CLIENT	PROJECT
Mr A Kirkpatrick	11767 Horrobin Farm, Turton

DRAWING TITLE
QUESTIONS FOR THE ENGINEER

Structural queries on the ICF approval drawings - sheet 1 of 1

STATUS	DRAWING No.	REV
FOR APPROVAL	UKPCS-002-EQ-01B	P01

EQ-02 D1: steel B-6 as the head of the 5575 opening (confirm interpretation)

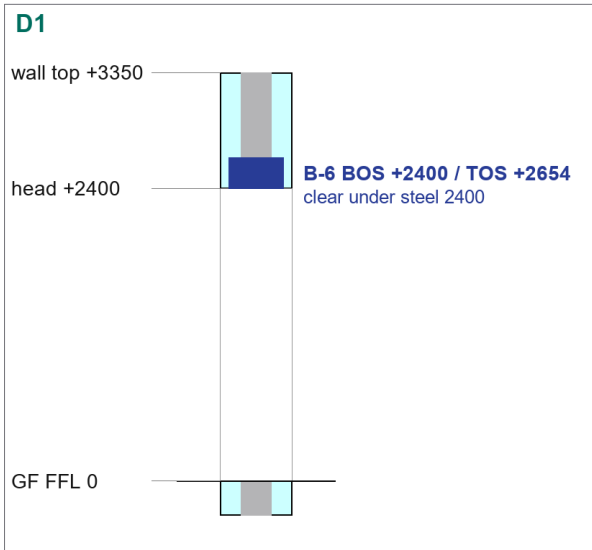
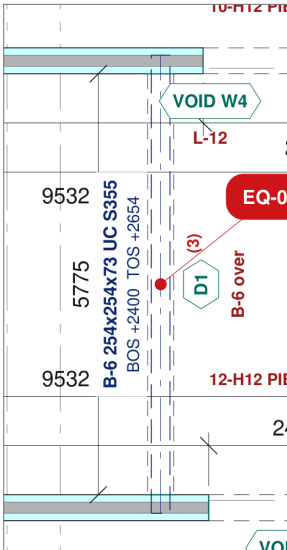
ISSUE D1 is the 5775 wide full-length opening in the ICF wall between the conservatory and the room to its east (Wall 21). Your drawing gives it no lintel mark and shows B-6 254x254x73 UC S355 (with 200x100x10 ledger angle one side) along that line. We have modelled B-6 at BOS +2400 / TOS +2654 as the head of the opening, with the structural opening in the ICF up to +2654 and ICF over the steel to the wall top at +3350, giving 2400 clear under the steel.

QUESTION Please confirm that B-6 forms the head of D1 as described (clear opening 2400 under B-6, ICF bearing on the steel above), or advise the intended arrangement.

EQ-03 Option B: steel lengths and bearings with the external ICF moved 100mm in

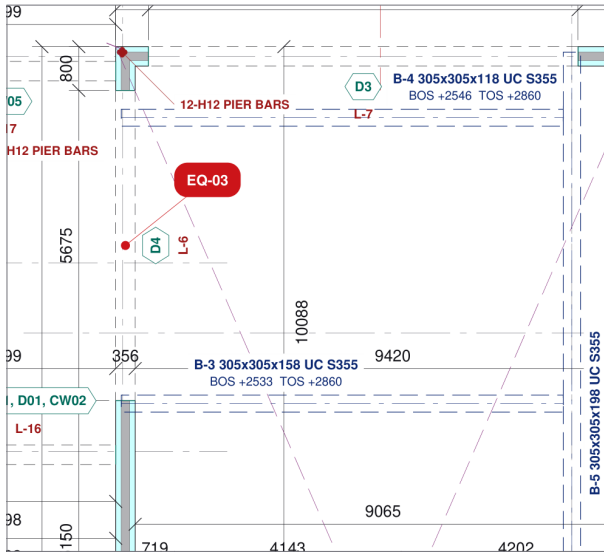
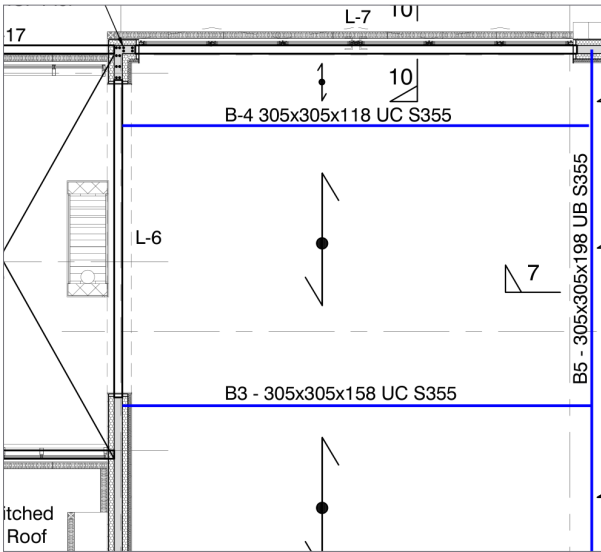
ISSUE In Option B every external ICF wall moves 100mm in from the RC raft edge. Steels have been adjusted to keep their bearing into the ICF: B-3, B-4 (west ends) and B-5 (north end), B-1 (south end) and B-7 (east end) are 100mm shorter; B-9 (south end) and the tie (west end) are 100mm longer; B-6 moves 100mm east and is 200mm longer (D1 5775). B-2, B-8 and C-1 are unchanged. The engineer's pier bars and wall starters move with the ICF corners and junctions; lintel spans over VOID W4 / W7 reduce by 200mm, D1 / CW05 / CWO1 openings widen by 200mm.

QUESTION Please confirm the steel lengths / bearings, the 200mm longer B-6 and the relocated pier bars are acceptable for Option B, and whether the RC raft edge detail (ICF now ~125mm in from the slab edge) needs revising.
